GRADING AND EROSION CONTROL DOCUMENTS FOR HONOR CHARTER SCHOOL

GEC COVER SHEET

HONOR CHARTER SCHOOL
HIGHMARK SCHOOL DEVELOPMENT
8250 BENT GRASS MEADOWS DR.

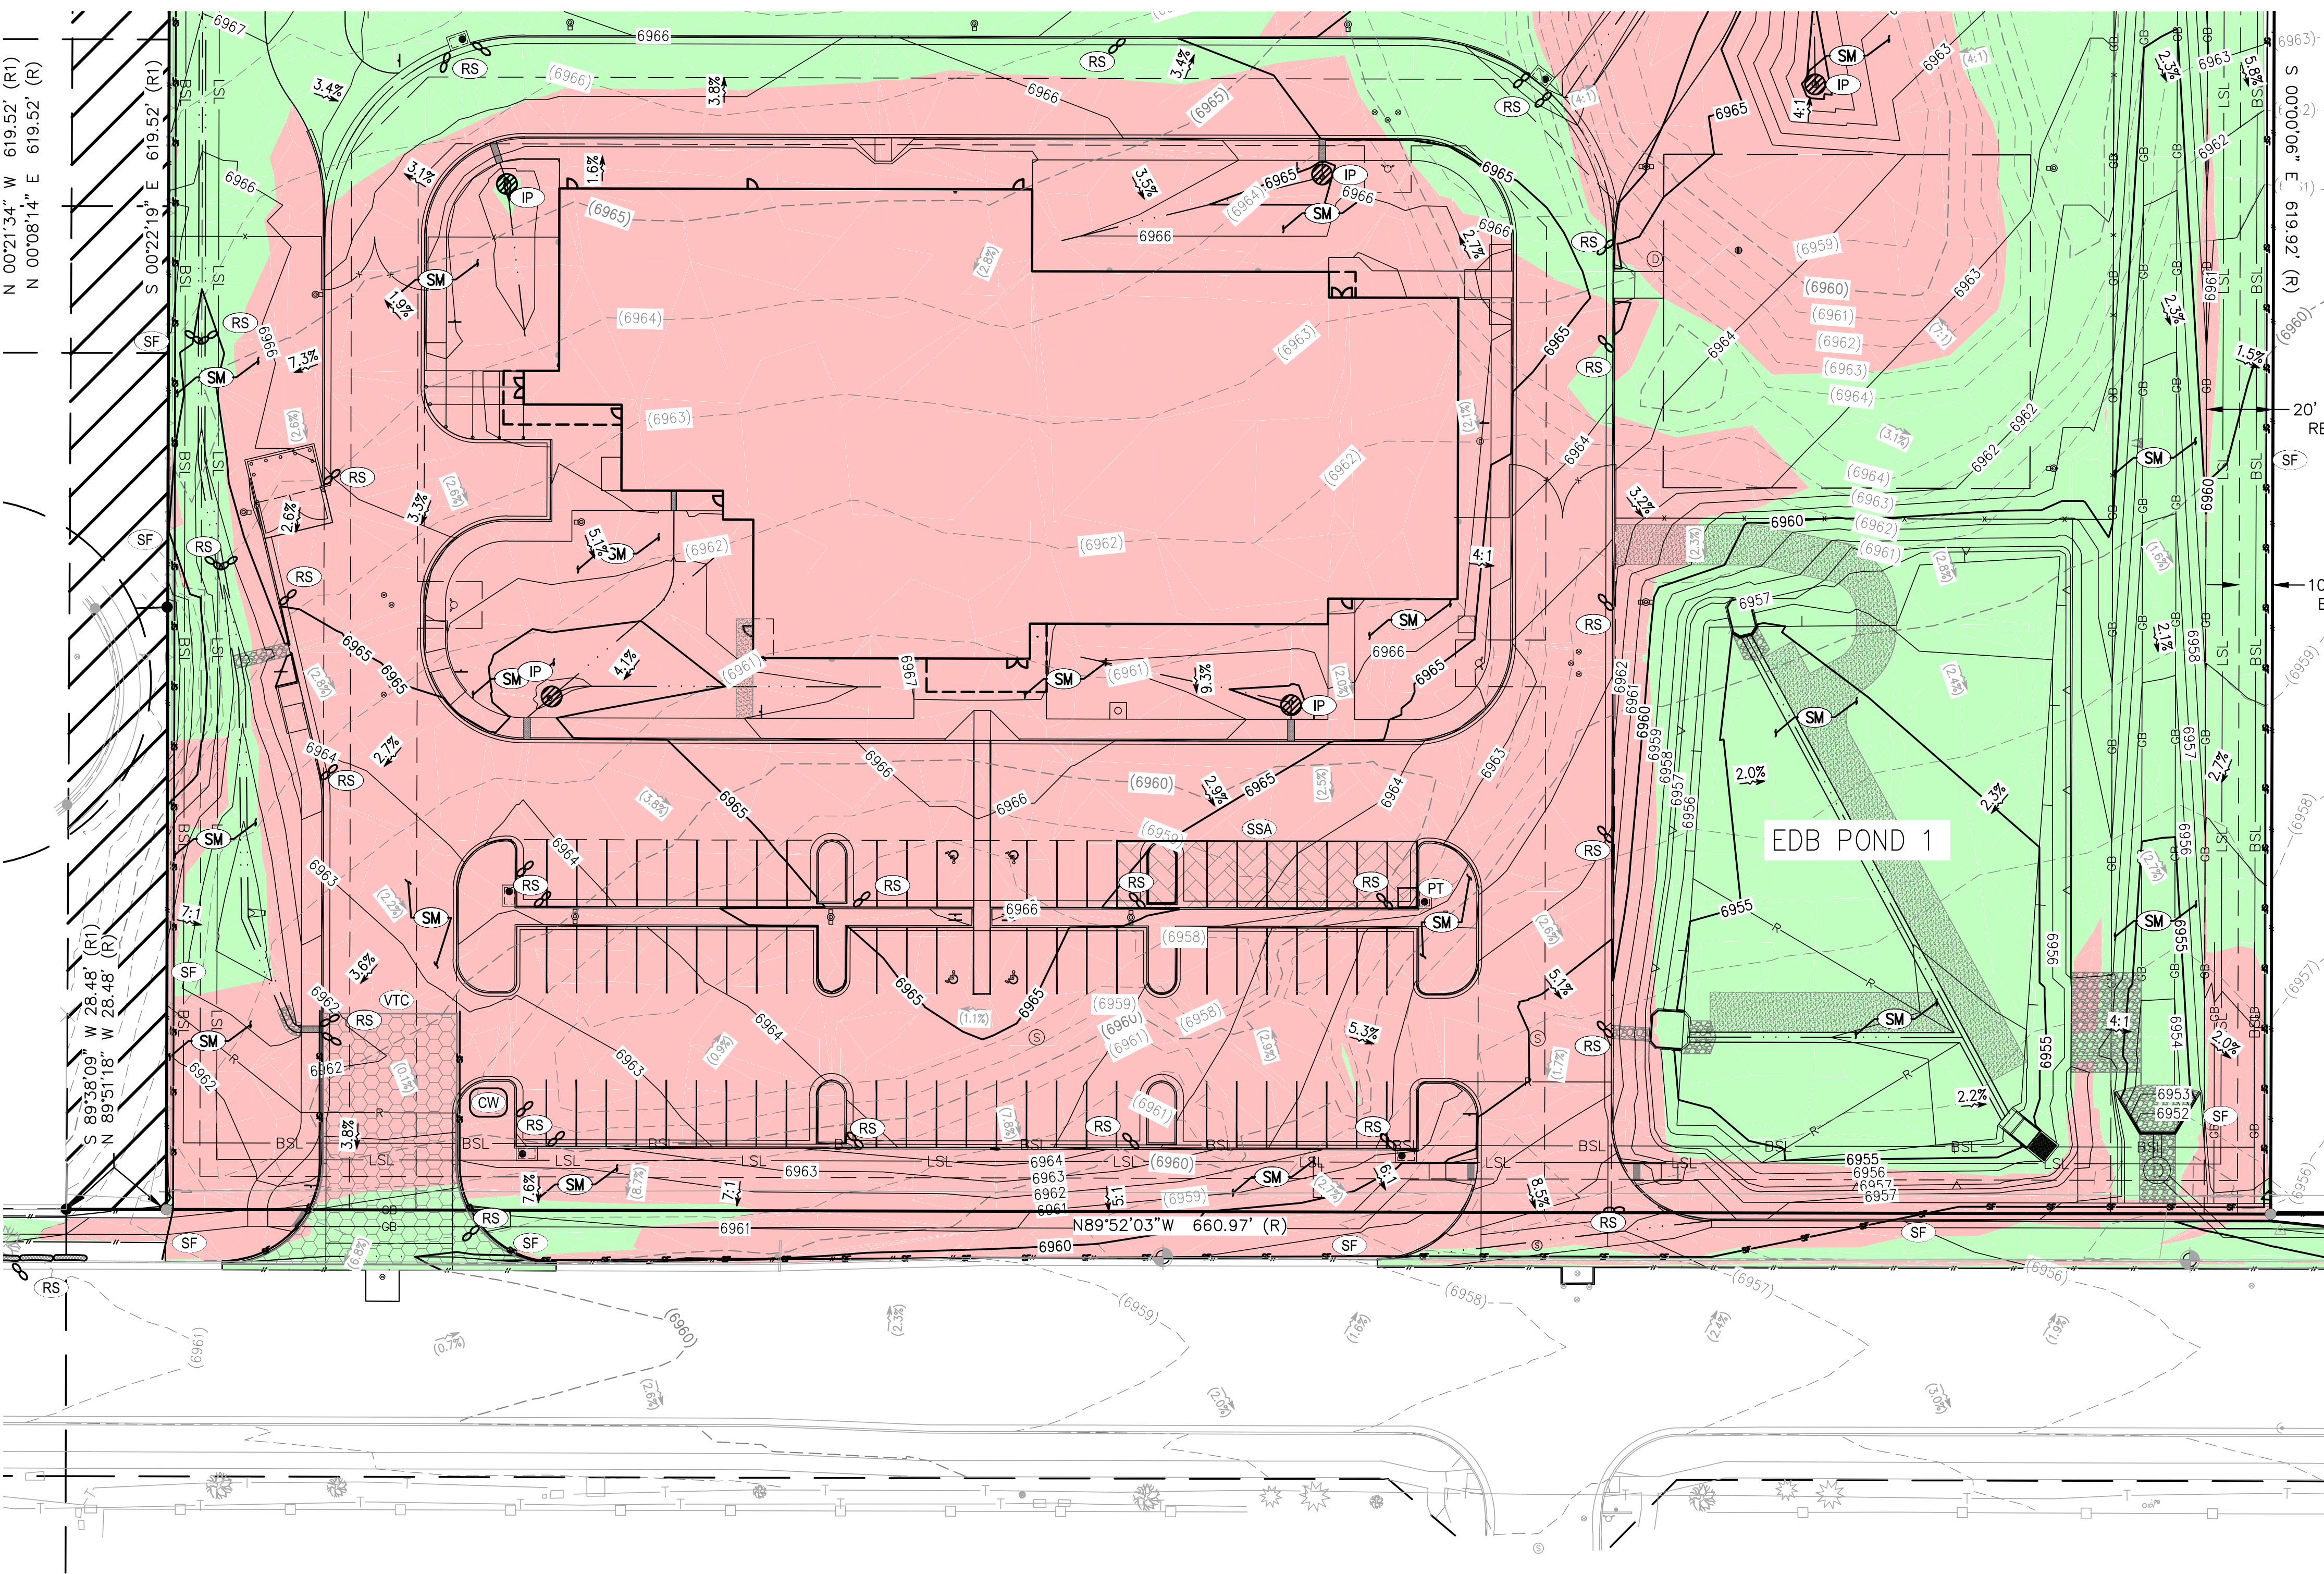
Show proposed drainage easements for pond and bypass channel on plans
